**SUBJECT: RECALL R09PY FMVSS 221 SCHOOL BUS BODY JOINT  
STRENGTH NONCOMPLIANCE-INCORRECT  
NUMBER OF RIVETS IN FRONT ROOF CAP**

# Front Roof Cap Joint Strength Noncompliance

**Models Affected:** 2008 through 2010 model Blue Bird **Micro Bird** school buses manufactured at Fort Valley, Georgia from July 22, 2007 through November 28, 2009

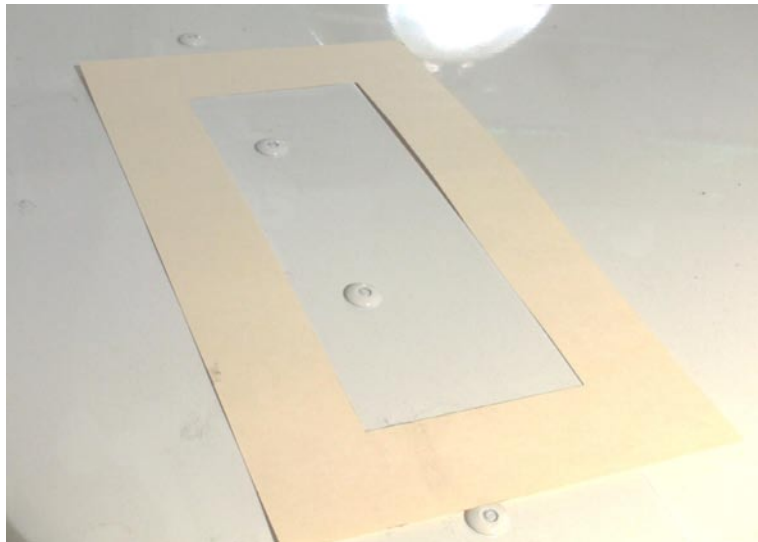
On some units, the incorrect amount of adhesive may have been used in some segments of the front roof sheet and front roof cap joint, resulting in noncompliance with FMVSS 221, School Bus Body Joint Strength.

Inspect the rivet spacing at the joint and install additional rivets as required by specification.

1. Inspect rivet spacing at front roof cap and front roof sheet joint. Joint must have a minimum of four rivets in any eight inch segment.
2. Place the template over the front roof cap joint rivets and parallel to the edge of the front roof cap, allowing front roof cap rivets to be exposed through the opening as illustrated below.

3. Move the template from one side of the front roof cap to the opposite side.
4. If a segment in the front roof cap joint contains less than four rivets, additional rivets are required. Mark each area that requires additional rivets.
